DOCUMENT 00 90 02 – ADDENDUM No. 02

- A. Project Name: CAPITAL PROJECT PHASE 4.
- B. Owner: OWEGO APALACHIN CENTRAL SCHOOL DISTRICT.
- C. Architect: HIGHLAND ASSOCIATES.
- D. Construction Manager: TAMCO LLC
- E. Architect Project Number: 2024-240P.
- F. Date of Addendum: APRIL 30, 2026.

HIGHLAND ASSOCIATES / TAMCO MANAGEMENT

Contractor Pre-Bid RFI Form

DRAWING NO:
AES A-150

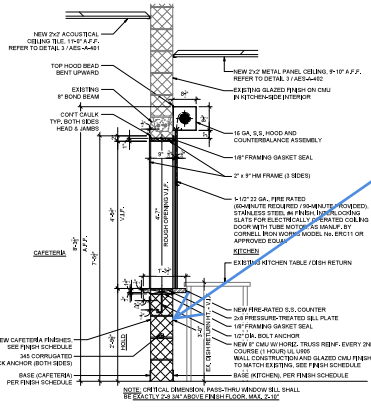
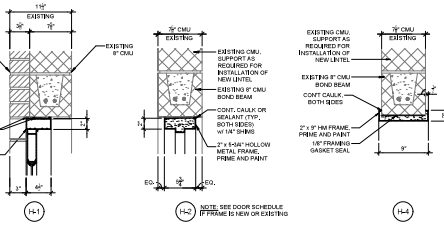
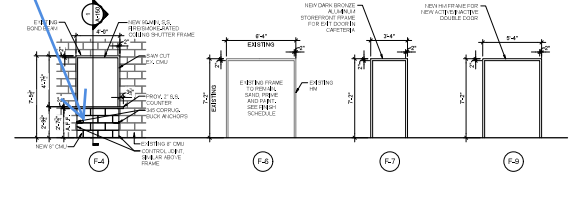
Please see the attached marked-up drawing from a masonry subcontractor. There's a concern about acquiring glazed masonry units to complete the wall patching at Kitchen 202 where the new fire shutter is to be placed. The small quantity required is the issue. Please advise if an alternative wall finish would be acceptable to complete the infill. Thank you.

Is existing finish on the kitchen side glazed CMU as stated?
 Refers to a finish schedule; none provided.
 Can ceramic tile or FRP be substituted? Glazed CMU of this
 quantity will not be entertained by the manufacturer.

ALTERNATIVE WALL FINISH (CERAMIC WALL TILE OR FRP) WILL BE ACCEPTABLE AT THE KITCHEN-SIDE OF WALL.

2024-240: OACSD CP PHASE 4 PB RFI 008
 OFA - CEILING TILE @ CORRIDOR C111.1

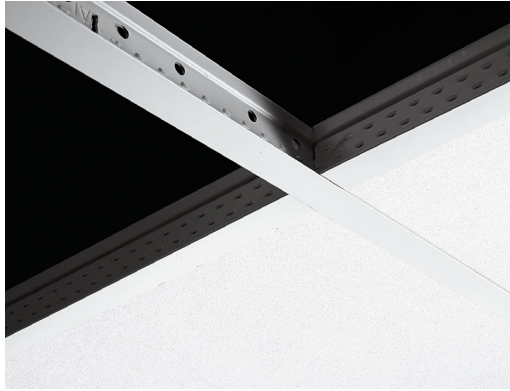
Finish Schedule on A601, undr ceiling finish, list "C-X". This does not correspond to
any of the ceiling types listed. Please advise.

ANSWER: CEILING FINISH "C-X" SHALL BE REPLACED WITH THE FOLLOWING CEILING TYPE

C-1 @ CORRIDOR C110 LOBBY C111, VESTIBULE C11.

SEE ATTACHED PD SHEETS FOR CEILING TYPE & GRID @ CORRIDOR C111.1.
